Cobra 138XLR / 139XLR Technical Bulletin 1209B

COBRA FIELD BULLETIN

SUBJECT: REVISION OF BULLETIN 1209 AND 1209A. D-26 SHORTING ON THE COBRA 138/139XLR.

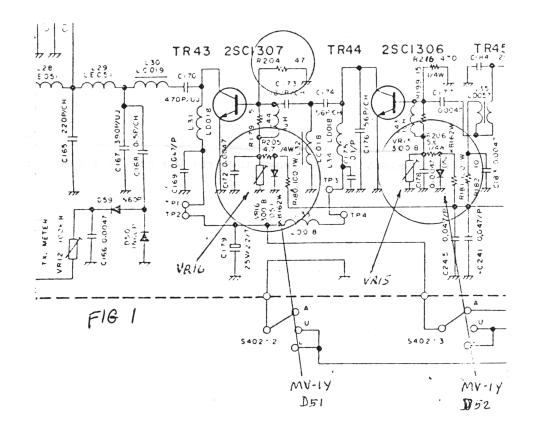
3. ADD A 330 OHM 1/8 WATT RESISTOR, DYNASCAN PART NO 002-108-5-331 FROM TOP OF VR8 A.M. TRANSMIT ADJUST TO EMITTER OF TR25. THE RESISTOR IS ADDED ON THE FOIL SIDE, CUTTING THE FOIL SO THE RESISTOR IS IN SERIES WITH VR8 AND THE EMITTER OF TR25. THE SCHEMATIC SYMBOL FOR THE RESISTOR IS R226.
